Driver Seat - LH Rear Bolt Cover Deformation

Service
 Category Vehicle Interior

Section Seat

YEAR(S)	MODEL(S)	ADDITIONAL INFORMATION
2014	Tundra

Figure 1. Front Seat Cushion Shield LH

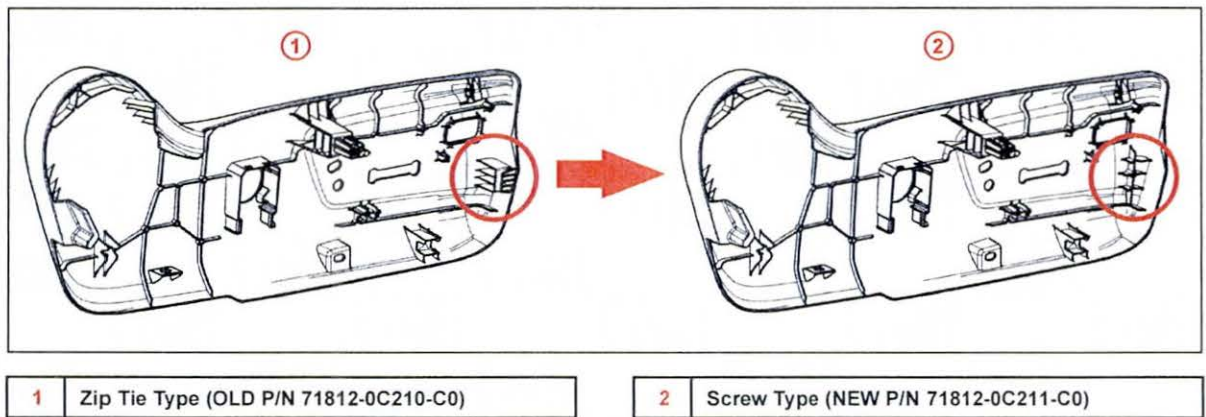
- 2014 Tundra:
Vehicle Interior – Seat – “Seat: Front Seat Assembly (for Power Seat): [Removal](#)”
2. Replace the original Front Seat Cushion Shield LH (zip tie type) with the NEW Front Seat Cushion Shield LH (screw type) and Front Seat Cushion Shield Wire LH.

Figure 2.

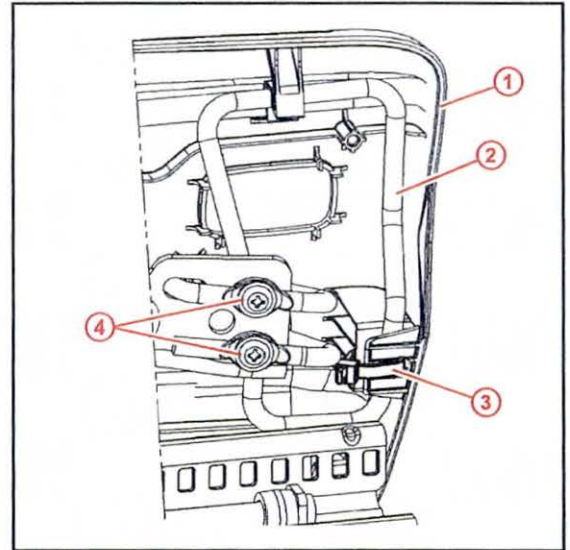
A. Remove the side shield (zip tie may be cut).

B. Remove the Front Seat Cushion Shield Wire LH from the frame by removing the 2 wire attachment screws.

Figure 3.

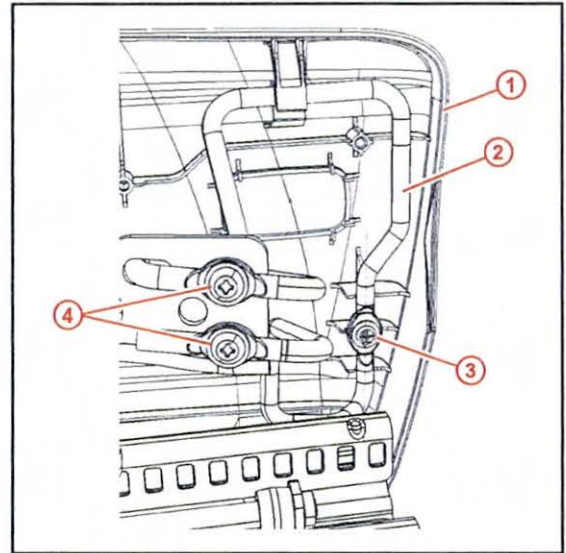
- C. Attach the NEW Front Seat Cushion Shield Wire LH.

- D. Attach the NEW side shield screw.
3. Replace the original Outer Rear Seat Track Bracket Cover LH with the NEW Outer Rear Seat Track Bracket Cover LH.

Figure 4.

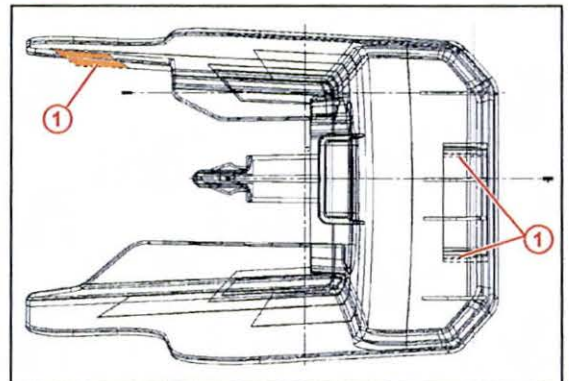
The rib on the new cover is longer than the original part by 15 mm.
